MECKLENBURG COUNTY HEALTH DEPARTMENT

APPLICATION FOR PERCOLATION TEST

SOIL INVESTIGATION REPORT

SITE INVESTIGATION REPORT
INDIVIDUAL SEPTIC TANK SYSTEM
WITH SUBSURFACE,
SOIL ABSORPTION,
EFFLUENT DISCHARGE

DIAGRAM OF PROPERTY

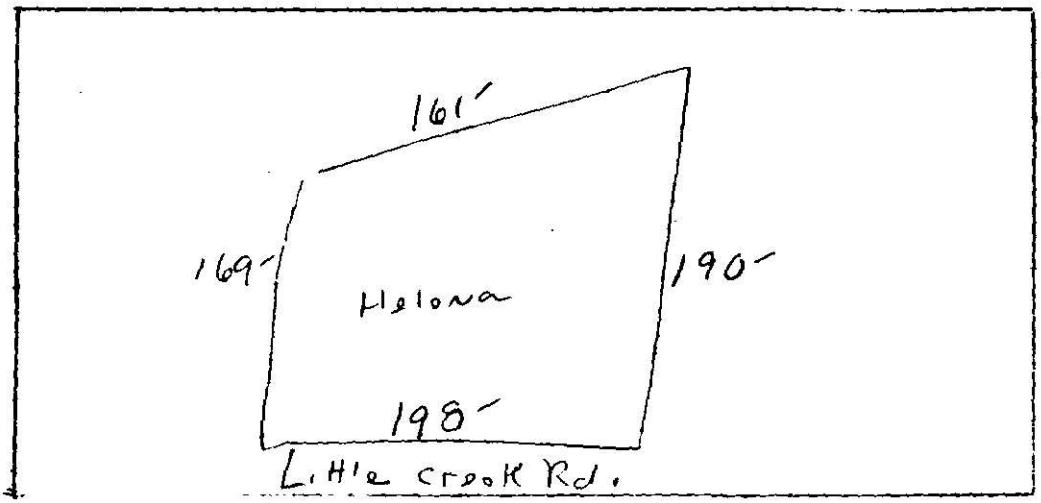
Soil Properties	Soil 1	Soil 2	Soil 3	Soil 4
1. Soil Series	Holona			
2. Soil Slope	unsuitable 2-6%			
3. Soil Depth	unsuitable <30"			
4. Soil Texture	unsuitable 2:1 Expanding Clay			
5. Soil Structure	unsuitable Massive			
6. Restrictive Horizons	—			
7. Soil Drainage	unsuitable perched high water table			
8. Soil Permeability (Percolation Rate)	unsuitable very slow >60 min/inch			
9. Other	—			
10. Overall Rating	unsuitable

Recommendations Based on this investigation, the lot was found to have soils dominantly unsuitable for installation of a septic tank system.

Lot rechecked 12-7-78. no change in suitability of lot. William A. Martin Soil Scientist
